Access Compliance Report Public Rights-of-Way (Curb Ramps)

Main Street: ARTISAN_ST Cross Street: WINSLOW_ST Location: E

ADA ID: RPRK211020164139 Ramp Type: Type 4 - Parallel Initial Pass/Fail: Fail Overall Compliance: No Severity Score: 30

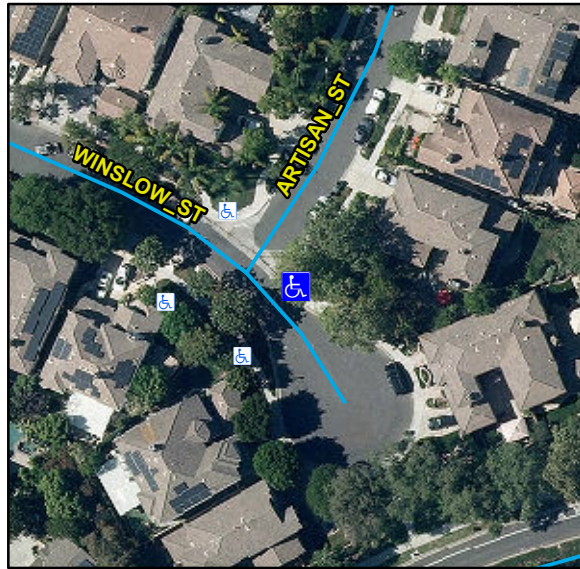
Compliance	Description	Data	Compliance	Description	Data
N/A	Ramp Length LT (in)	117	N/A	Ramp Length RT (in)	116
Yes	Ramp Width LT (in)	54	Yes	Ramp Width RT (in)	54
Yes	Ramp Run Slope LT (%)	6	No	Ramp Run Slope RT (%)	12.3
Yes	Ramp Cross Slope LT (%)	1.4	Yes	Ramp Cross Slope RT (%)	0.2
N/A	Landing Present	N/A	N/A	DWS Provided	N/A
N/A	Landing Length (in)	N/A	N/A	DWS Contrast	N/A
N/A	Landing Width (in)	N/A	N/A	DWS Length (in)	N/A
N/A	Landing Run Slope (%)	N/A	N/A	DWS Full Width	N/A
N/A	Landing Cross Slope (%)	N/A		DWS Offset Type	N/A
N/A	Landing Movement Obstructed?	N/A	N/A	DWS Offset Left (in)	N/A
	Landing Movement Type	N/A	N/A	DWS Offset Right (in)	N/A
N/A	Landing Shared	N/A			
N/A	Clear Space	Yes			
N/A	Clear Space To Crosswalk (in)	N/A			
N/A	Marked Crosswalk 1	No	N/A	Marked Crosswalk 2	No
	Crossing 1 Direction	NW		Crossing 2 Direction	SW
	Marked Crosswalk 1 Width (in)	N/A		Marked Crosswalk 2 Width (in)	N/A

Remove & Replace Curb Ramp With Two New Directional Ramps or Equivalent.
